SIB 52 01 19 DELIVERY STOP AND RECALL 19V-135: 2ND ROW SEAT CONNECTION (Option 4U5)

This Service Information bulletin replaces SI B52 01 19 dated March 2019

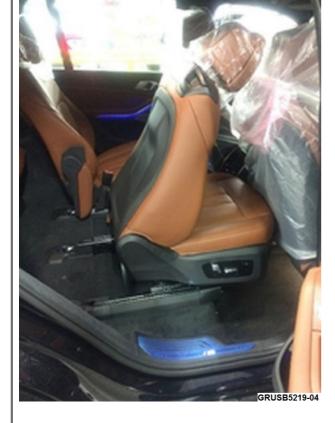
Remove bolts 1 and 2 with the Wheel Lock Removal kit, special tool 0 495 223 (36 1 325), Socket # 32.

Note: Replace the bolts (Collar bolt M10 X 28).

Torque the M10 bolts to 42 Nm.
